## Change of indicators for the MPS product family

### 1. General Overview

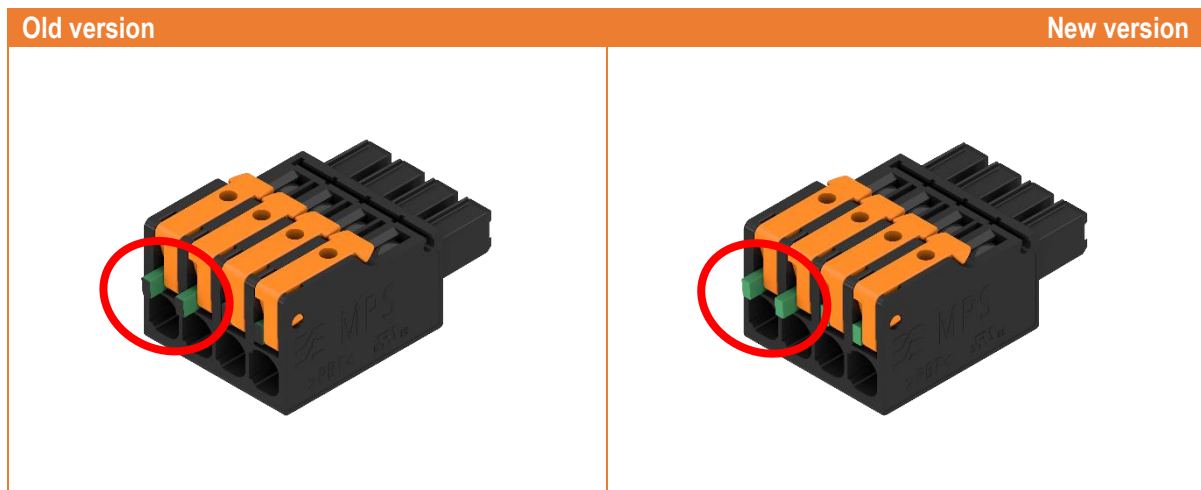
As part standardization of the appearance across all SNAP IN products, the indicator of the new version will now be entirely green. Material, shape, and function remain identical, only the black printing on the front side has been removed.
